# **Westinghouse Containment Analysis Methodology – PWR LOCA Mass and Energy Release Calculation Methodology**

**WCAP-17721-NP-A**  
**Revision 0**

August 24, 2015

SUBJECT: FINAL SAFETY EVALUATION FOR WESTINGHOUSE ELECTRIC COMPANY (WESTINGHOUSE) TOPICAL REPORT (TR) WCAP-17721-P, REVISION 0, AND WCAP-17721-NP, REVISION 0, "WESTINGHOUSE CONTAINMENT ANALYSIS METHODOLOGY - PWR [PRESSURIZED WATER REACTOR] LOCA [LOSS-OF-COOLANT ACCIDENT] MASS AND ENERGY RELEASE CALCULATION METHODOLOGY"

Figure 5-7 Integrated Long-term Break Mass Release Comparison

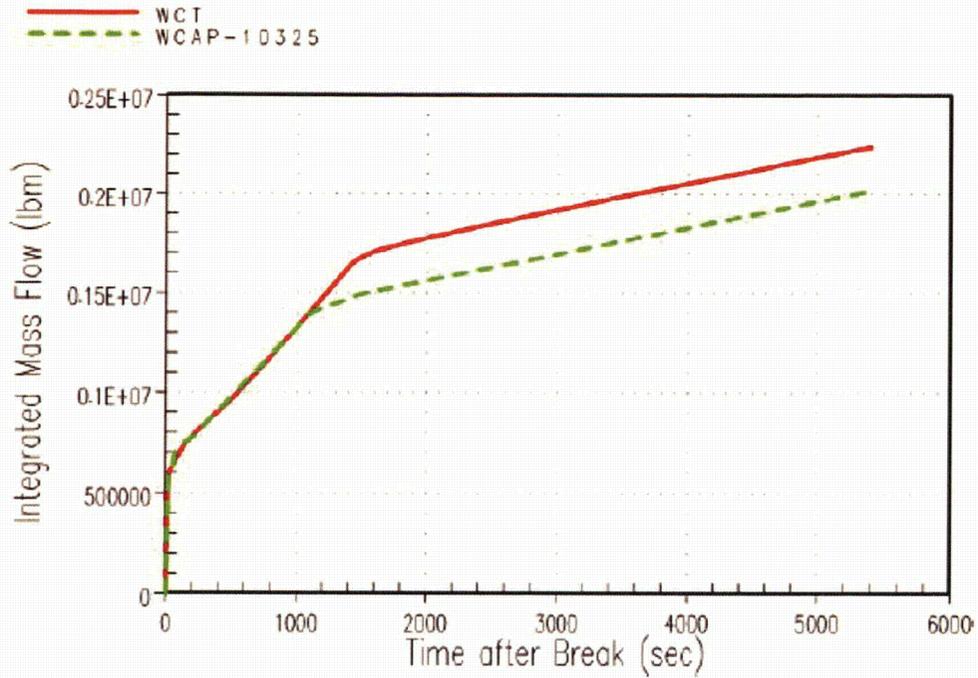
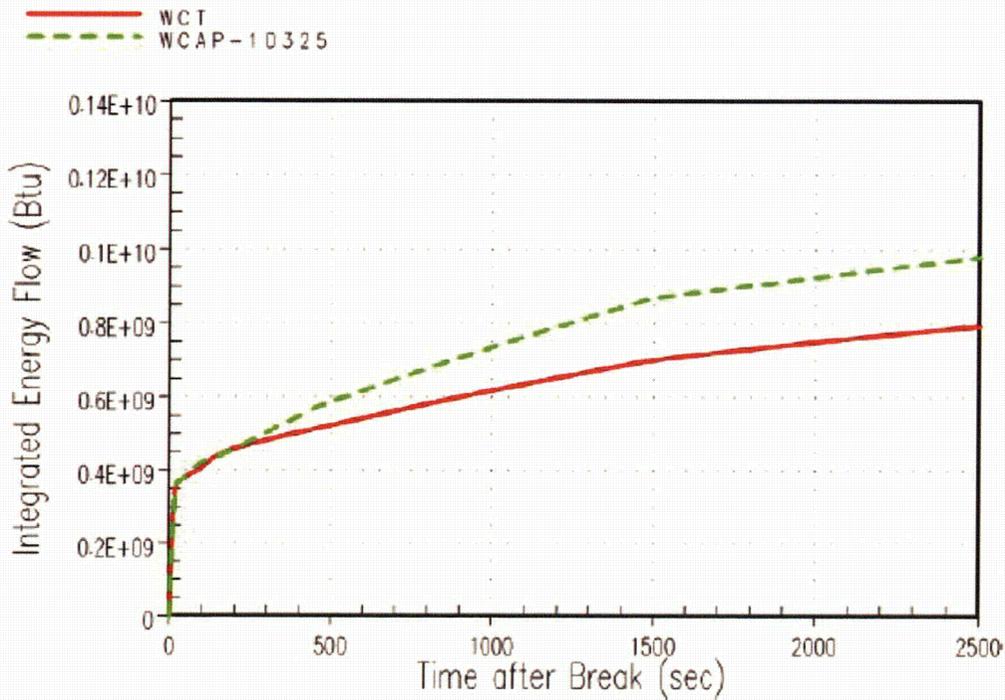
<b>24-hr integrated mass and energy release via break</b>	
<i>Please provide the integrated mass and energy release from break up to 24-hour (86400 seconds) for Figures 5-7 and 5-8; similarly, for DEHL case (Section 5.4).</i>	
SCVB-RAI-8, 24-hr Integrated Mass and Energy Release via Break (Reference 11)	
<b>Disagreement Level</b>	N/A
<b>SE Section</b>	Various
<b>Comment</b>	None
<b>Reference of Response</b>	1. SCVB-RAI-8, 24-hr Integrated Mass and Energy Release via Brea (Reference 13)

Figure 6-2 Long-term Containment Pressure Comparison

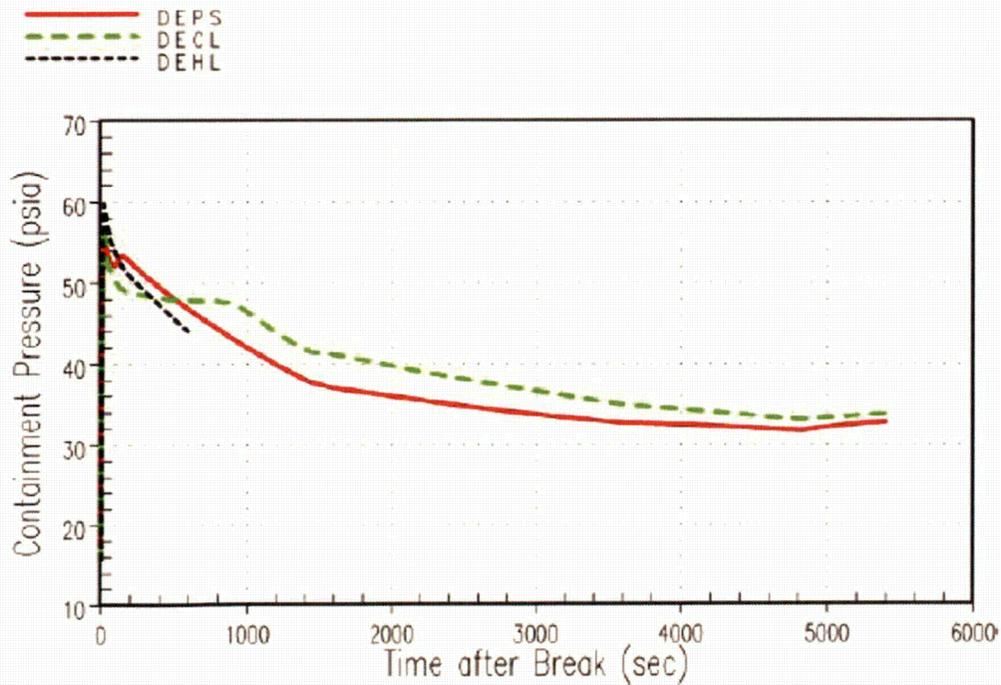
<b>24-hr containment pressure</b>	
Figure 6-2 shows that the containment pressure, especially for double-ended pump suction (DEPS) case, is rising after 5000 seconds. Provide 24-hour (86400 seconds) containment response for both DEPS (Section 5.3) and double-ended hot leg (DEHL) (Section 5.4) cases. Provide the analysis procedure (methodology) to assure the adequacy of containment heat removal system by demonstrating, for example, that the containment pressure will be below 50 percent of peak pressure after 24-hour into LOCA (NUREG-0800, "Standard Review Plan," Section 6.2.2, "Containment Heat Removal Systems.").	
SCVB-RAI-7, 24-hr Containment Pressure (Reference 11)	
<b>Disagreement Level</b>	N/A
<b>SE Section</b>	Various
<b>Comment</b>	None
<b>Reference of Response</b>	1. SCVB-RAI-7, GOTHIC Running In Parallel With WC/T (Reference 13)
